Kennett Square Historic Architecture Review Board Written Report to Borough Council

Item #7.b

PROPERTY LOCATION: 100 -118 E Cedar Street

PROPOSED WORK: Renovation to front of buildings, additions to the rear of each structure

2
A-2 REAR ELEVATION
SCALE: 1/4" = 1'-0"

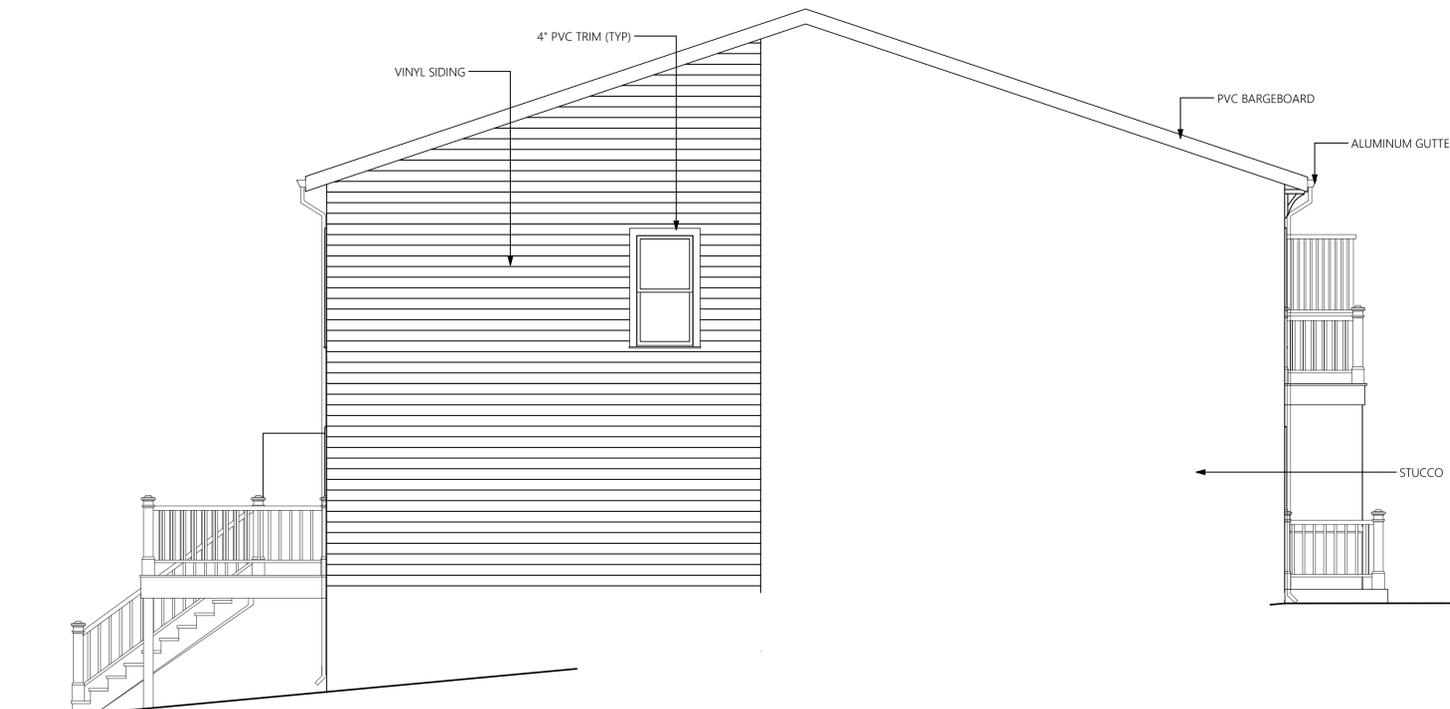
<p>appropriateness of the proposed work or project and the extent to which it will preserve or destroy the historic and/or architectural character and nature of the Historic District.</p>	
<p>The specific recommendations of the HARB, based on findings of fact, as to the action by Borough Council to approve or deny the issuance a Certificate of Appropriateness.</p>	<p>The HARB did stipulate one change, to which the applicant agreed. The submitted drawings showed the addition of second floors doors to access the front balconies. These drawings relocated the doors away from the original placement of existing windows. The HARB requested that the new doors be placed in the same locations as the existing windows.</p>
